### APR1400 Design Certification

**RAI No.:** 355-8438

**SRP Section:** 09.05.04 – Emergency Diesel Engine Fuel Oil Storage and Transfer System

### **Question No. 09.05.04-8**

Schematic Diagram of Diesel Fuel Oil Storage Tank HVAC System

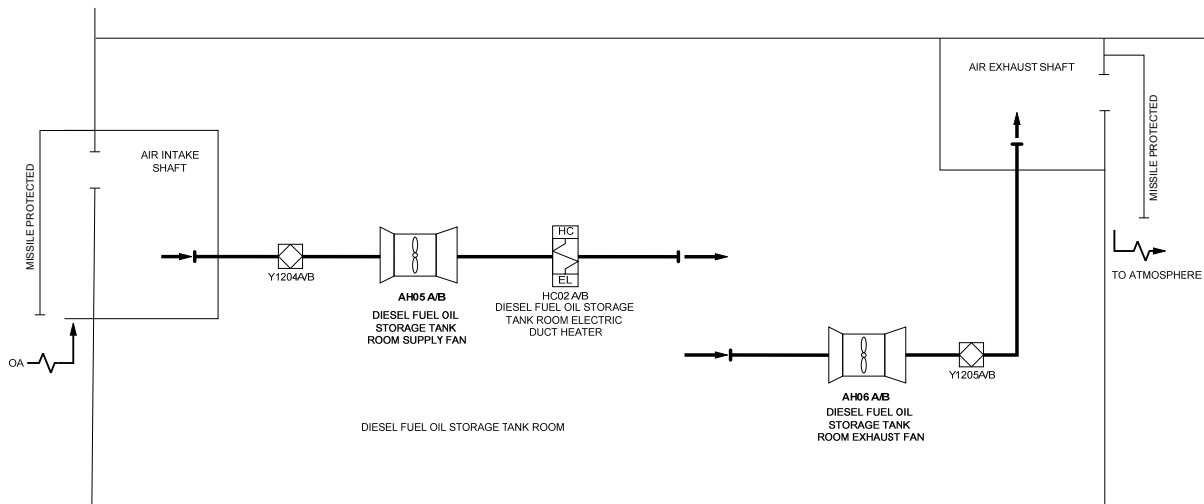
Please describe the codes and standards that will be applied to the coatings on the underground tanks, piping, and other components. In addition, describe your plans to add this information to the FSAR. This information is needed for conformance with position C.9 of Regulatory Guide 1.137, Rev. 2, which states that external corrosion should be addressed by following NACE International standard practice SP0169-2007, "Control of External Corrosion on Underground or Submerged Metallic Piping Systems." If SP0169-2007 is not being used, provide a justification for the proposed alternative. For additional background, the staff notes that License Renewal Interim Staff Guidance, LR-ISG-2015-01, "Changes to Buried and Underground Piping and Tank Recommendations," identifies loss of material on steel and copper components in underground vaults due to moisture in the air.

In the APR1400 design, the diesel fuel oil storage tanks and associated piping are located in vaults, which have dedicated HVAC systems as described in DCD Tier 2, Subsection 9.4.5.2.1.3. Supply and exhaust fans for the diesel fuel oil storage tank rooms operate continuously to prevent possible accumulation of oil fumes and to provide ventilation during all modes of plant operation. The electric duct heater operates to maintain the minimum required room temperature in the diesel fuel oil storage tank room. A sketch of the dedicated HVAC system is shown below (DCD Tier 2, Figure 9.4.5-1 provides a more detailed drawing of the system).

Therefore, the air condition in the vault does not have higher moisture content than uncontrolled indoor air conditions in plant spaces within buildings.
